APPLICATION NO.	ISSUE DATE	PATENT NO.
17/677,210	13-Feb-2024	11898366

Application Data Sheet 37 CFR 1.76	Attorney Docket Number	9693-012A-CON2
	Application Number	
Title of Invention	SHELTER AND HUB SYSTEM

Figure 2

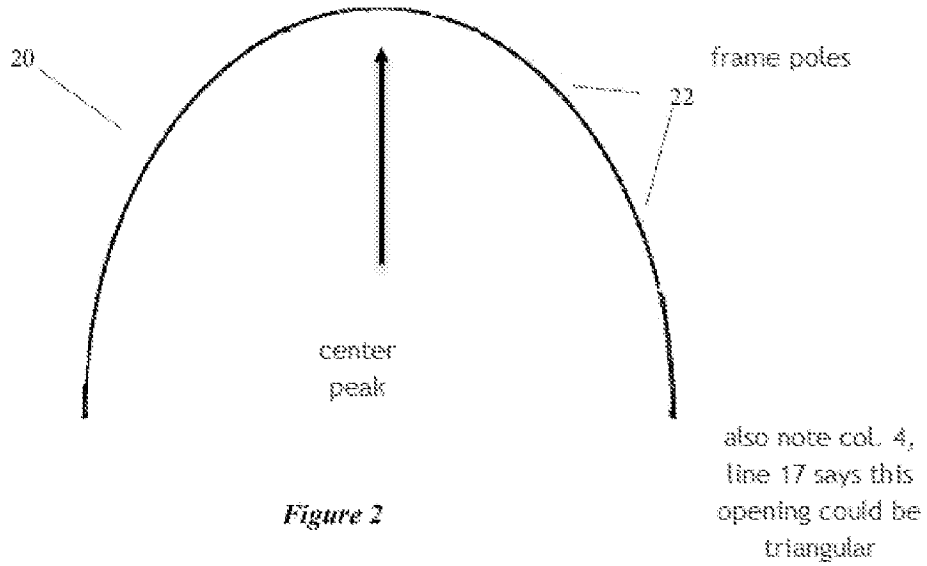
5. Claims 1-13, as best understood, are rejected under 35 U.S.C. 102(a)(1) as being anticipated by U.S. Patent 8,001,987 to Williams.

Williams provides a four sided shelter 10 having arched framed 20 exterior openings on each of the four sides. The openings formed of frame poles 22 forming a center peak.

A ring 40 forms an upper frame to provide substantially triangular framed corners or interfaces between adjacent sides. The framed shelter covered with a canopy. Second through fifth shelters 90/92/94/96 mate with the framed arched opening and may provide continuous interior space therebetween see at least the left hand side of figure 9 which show a side panel completely removed between the center or "hub" shelter and left or second shelter. Also, see Figure 18 where the second shelter has a rectangular perimeter foot print. With respect to claim 15, col. 4, lns 14-18 recite the

FIG. 1

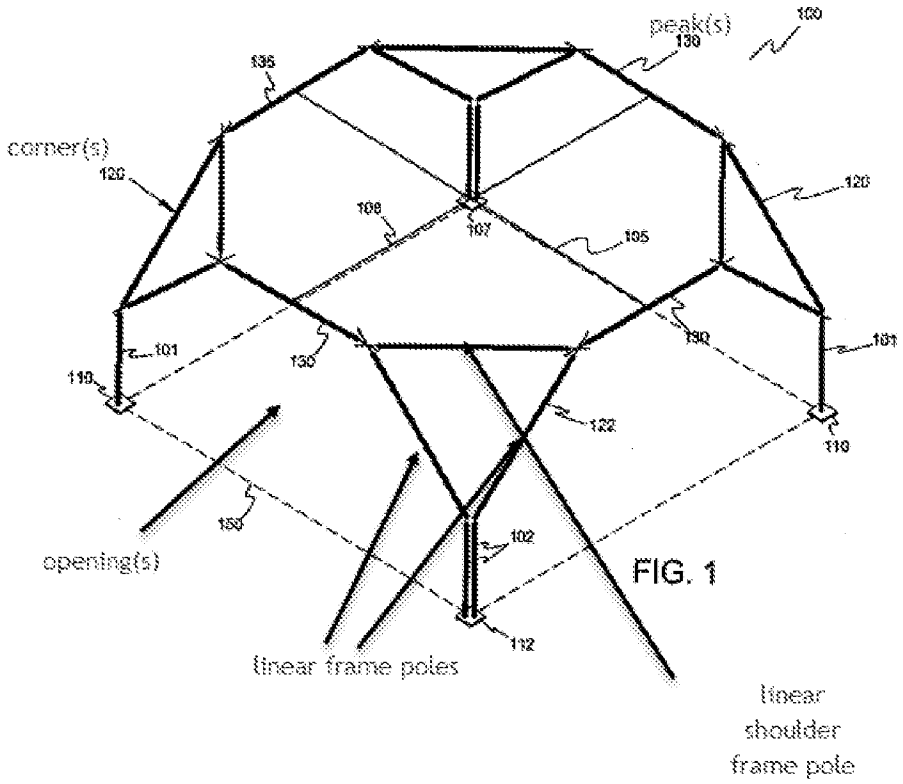
6. Claims 14, 15, and 17-20, as best understood, are rejected under 35 U.S.C. 102(a)(1) as being anticipated by U.S. 2008/0006316 to Jensen.

Note the marked up figure below.

FIG. 19

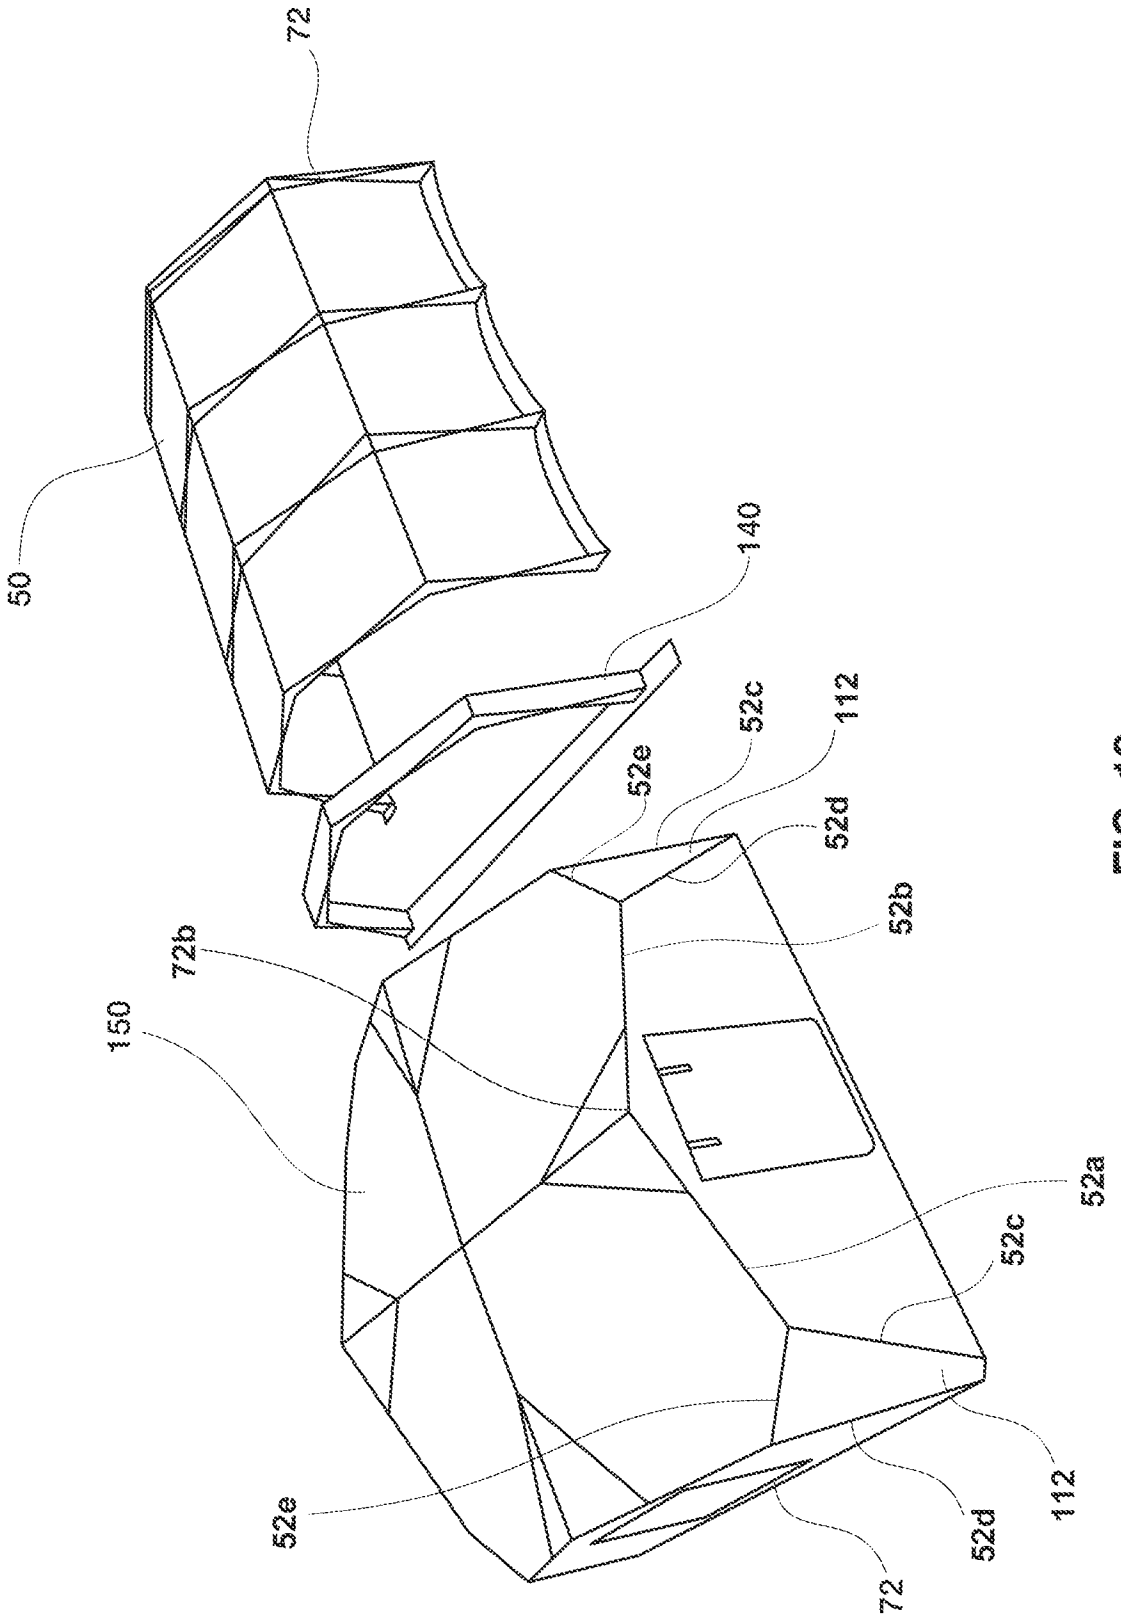
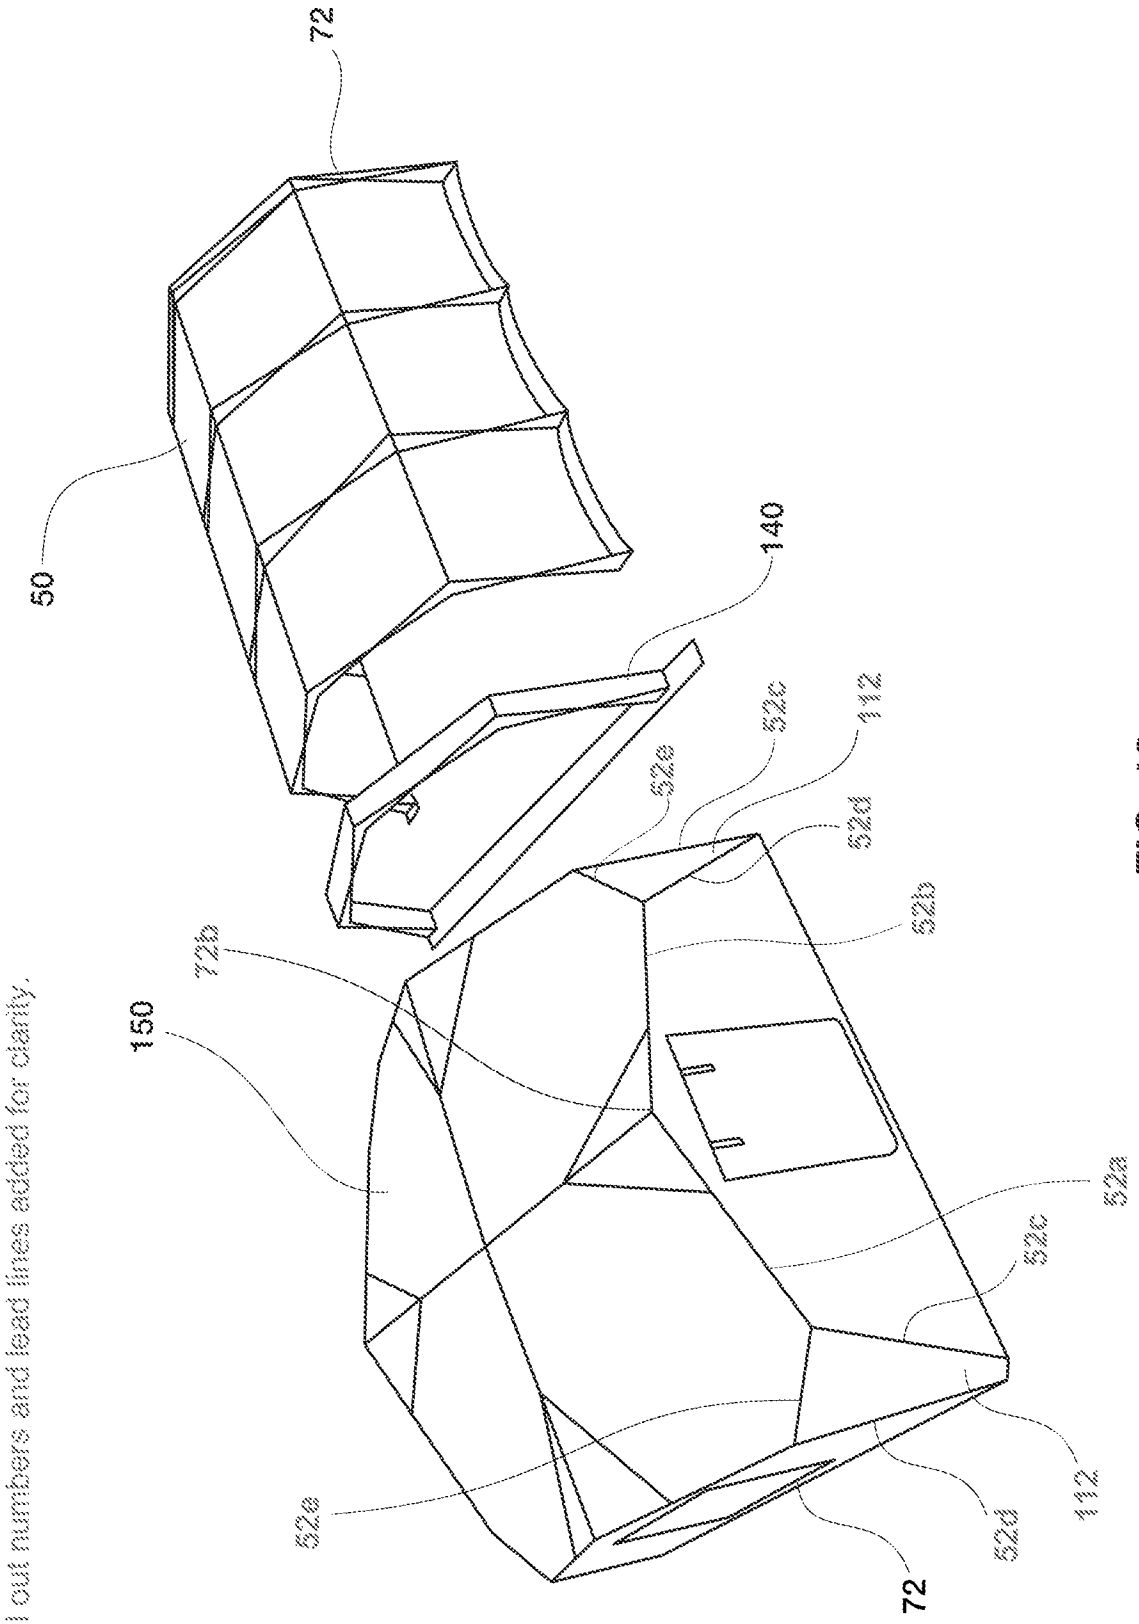
3. The drawings are objected to under 37 CFR 1.83(a). The drawings must show every feature of the invention specified in the claims. Therefore, the triangular frame support between each of the sides at each side interface, the triangular canopy portions and the outer frame perimeter, attached to and extending outwardly from the second shelter exterior frame opening must be shown or the feature(s) canceled from the claim(s). No new matter should be entered.

The claims as amended do not contain the language of the drawing objection in para. 2 of the office action and it is believed therefore it has been overcome. The drawings have been amended for consistency in showing elements and for addition of call out numbers.

Call out numbers and lead lines added for clarity.
